Charlotte Department of Transportation Memorandum

Subject: Rezoning Petition 15-057: Approximately 1.1 acres located on the north side of East Woodlawn Road between Park Road and Brandywine Road.

Figure 1

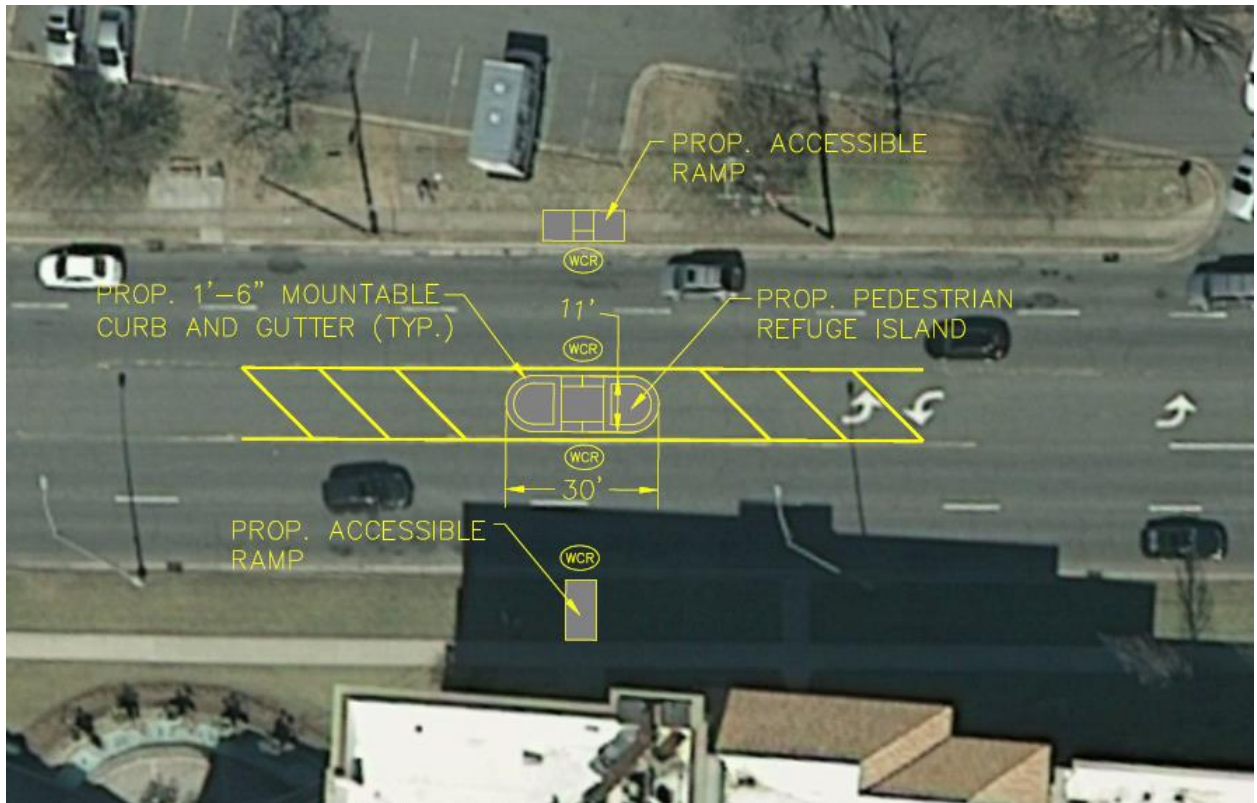
1. CDOT requests the petitioner revise the pedestrian refuge island dimensions and associated pavement markings to the conceptual design shown in Figure 1 below.

Figure 2

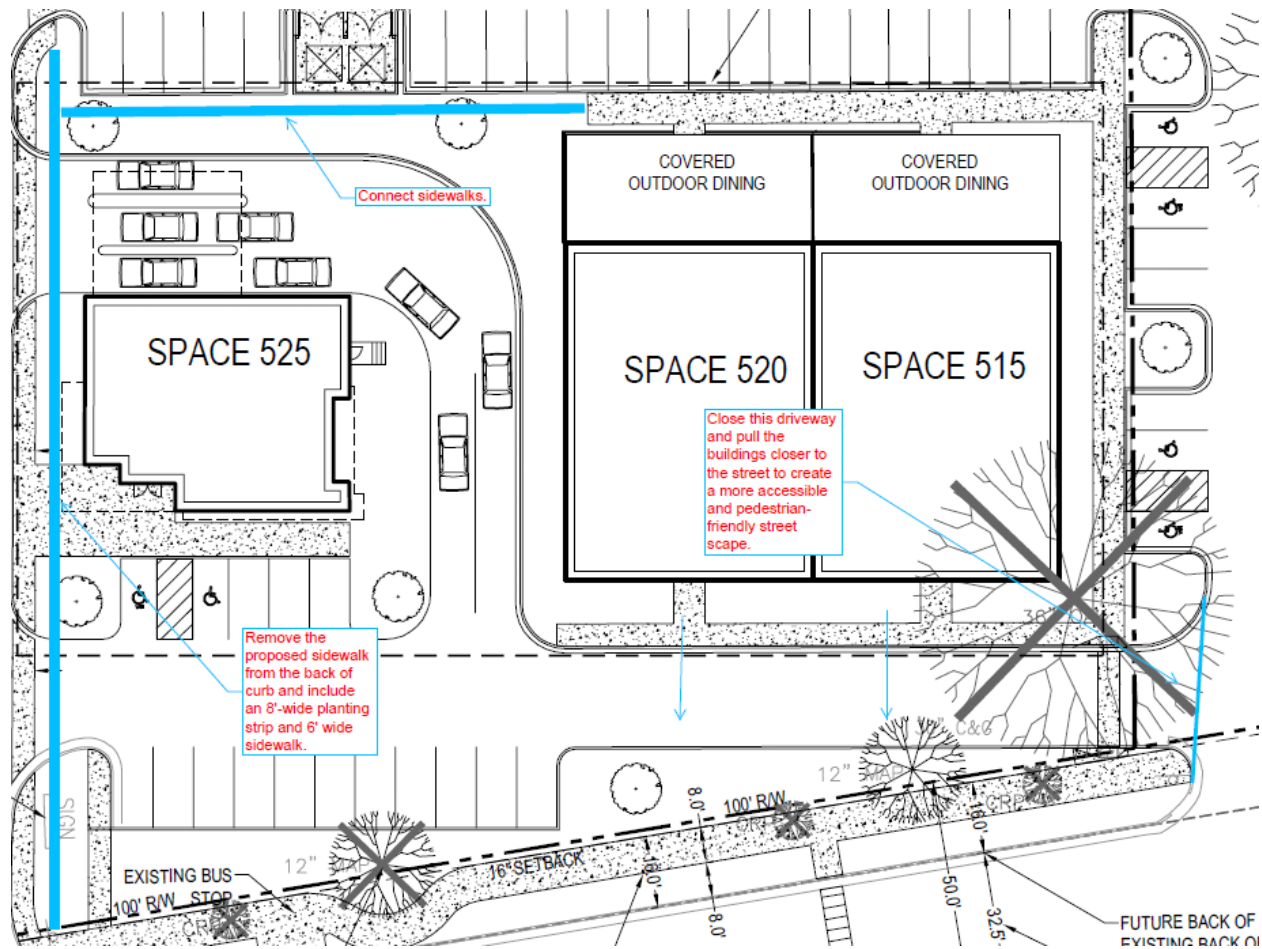
2. For the existing north/south private drive, CDOT requests the proposed back-of-curb sidewalk be relocated to create an 8'-wide planting strip and 6'-wide sidewalk adjacent to the westernmost proposed building (Space 525). CDOT also requests the sidewalk on the north side of the site get connected to the aforementioned sidewalk on the west side of the site (Figure 2).
3. It is our understanding that our Planning staff would like relocate the proposed buildings closer to Woodlawn Road to create a more urban design that is consistent with the recommendations of the Woodlawn area plan. In keeping with this goal, we recommend eliminating the southernmost driveway aisle and driveway connection to the existing 5th/3rd bank. See Figure 2 below.
